Southend-on-Sea Borough Council

Development Control Committee 15th January 2020

SUPPLEMENTARY INFORMATION

Seaway Car Park, Seaway, Southend-on-Sea

Page 11 – Site Plan

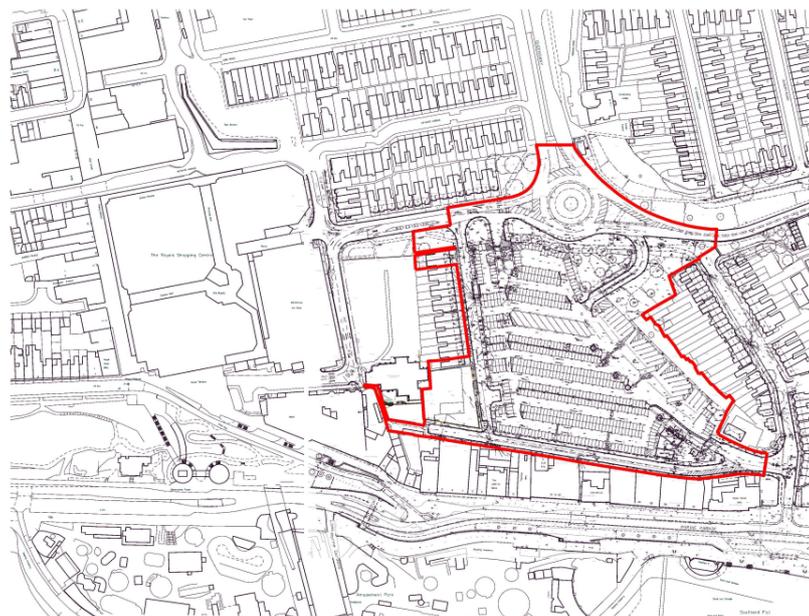
There is a slight discrepancy in the site location plan included within the agenda. For clarity, the site location plan submitted with the application is included below.
